NUREG-1437, Supplement 29
Vol. 2

**Generic Environmental
Impact Statement for
License Renewal of
Nuclear Plants**

**Regarding
Pilgrim Nuclear Power Station**

Final Report – Appendices

Figure 1: Winter Flounder – Annual Abundance of Sub-adults

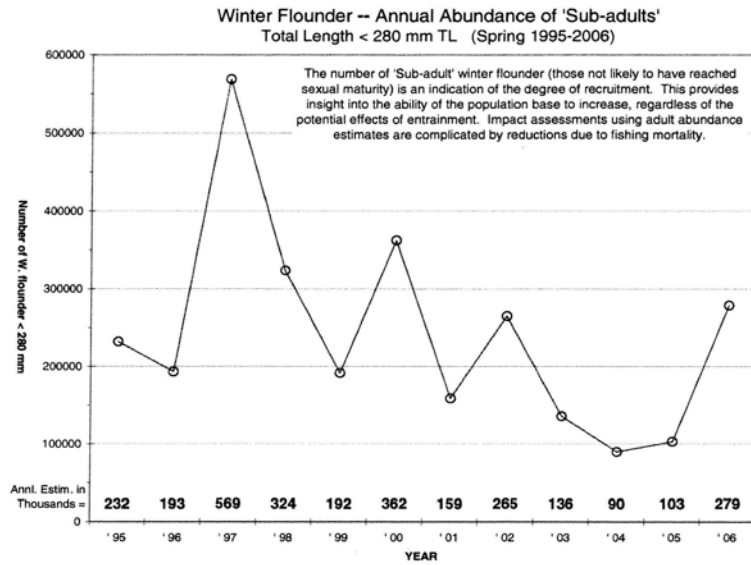
Page 2-68, lines 23-29: states "... data from the local population ... indicate that the annual abundance estimates of winter flounder in western CCB continue to decline (Figure 2-8)." This sentence implies that the "trends" from the prior paragraph are not matched by the abundance estimates in the vicinity of PNPS. This is an erroneous conclusion for two reasons: 1] it is an incorrect inference from the data in Figure 2-8 (PNPS's annual 'Area Swept' monitoring effort), and 2] it falsely presumes that the information given in the first paragraph constitutes evidence that a 'trend' is present in the Gulf of Maine winter flounder abundance data (see comment above). Simply because the 2005 winter flounder collection numbers were the smallest catch over the time series does not mean there is a declining trend (based on the three previous years). In fact, the number of sub-adult winter flounder collected in the most recent 'Area Swept' survey increased substantially. The 2006 estimate of immature winter flounder (total length less than 280 mm) was the fourth highest over the 12-year series, indicating that a healthy level of recruitment continues to occur in the vicinity of PNPS (see Figure 1 on the following page). Given that fish populations will often exhibit substantial variations as a natural consequence of environmental factors, the fluctuations observed over the 12-year history of the 'Area Swept' winter flounder abundance monitoring do not constitute a declining trend.

Figure 2: Mean numbers of wild young of year winter flounder collected by 100-ft beach seine in Plymouth Harbor (during the month of July) from 2002-2006.

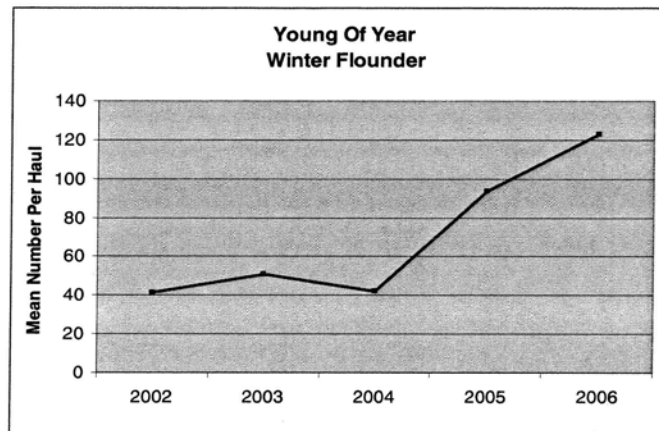
Additional information currently available also suggests that the winter flounder population in the Cape Cod Bay area is not in a downward trend. Beach seine sampling in Plymouth Harbor completed in conjunction with Entergy's young winter flounder hatchery release program indicate that numbers of young, wild fish remain strong and in fact have increased over the past two years (see Figure 2 below). It is also interesting to note that numbers of young fish collected during the summer do not appear to be correlated with the number of larvae entrained at PNPS the previous spring. This local field data suggest that numbers of winter flounder entrained do not translate into reduced numbers of young fish.
